**PREVOST**

**WARRANTY  
BULLETIN**

Wb98-04

<b>DATE :</b> March 1998	<b>SECTION :</b> 06
<b>SUBJECT :</b> REPLACEMENT OF REAR START SWITCH BOX

FIGURE 2 : REAR START SWITCH BOX

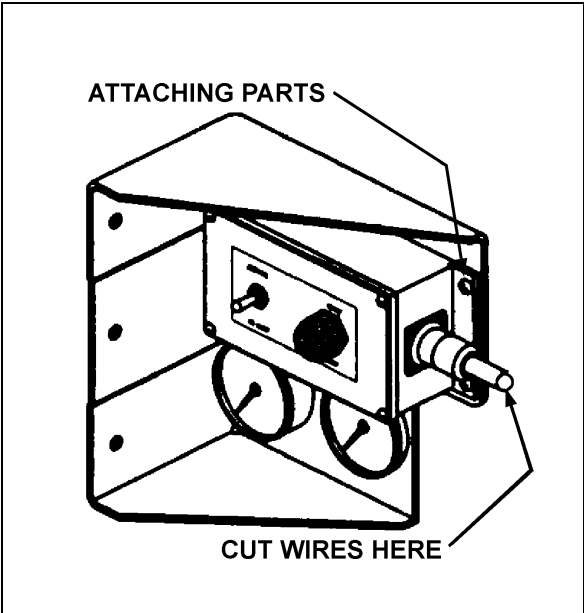
On the above-mentioned vehicles, rear start switch box is replaced with a watertight assembly.

1. Open engine compartment door (refer to fig. 1).
2. Cut wires as close as possible to rear start switch input connector (refer to fig. 2).
3. Unfasten rear start switch box attaching parts and remove the box, keep attaching parts aside.
4. Secure new rear start switch box (Prévost #381804) using attaching parts.
5. Remove about 3/8 inch of sheath covering each wire and crimp a contact pin (Prévost #561608) onto each wire.

FIGURE 3 : CONNECTOR

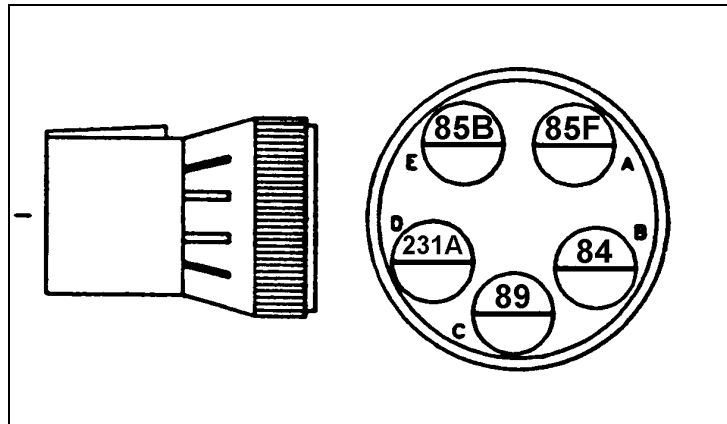
- Carefully insert contact pins into connector housings (Prévoist #562566) as per figure 3 and join connector with rear start switch box input connector.
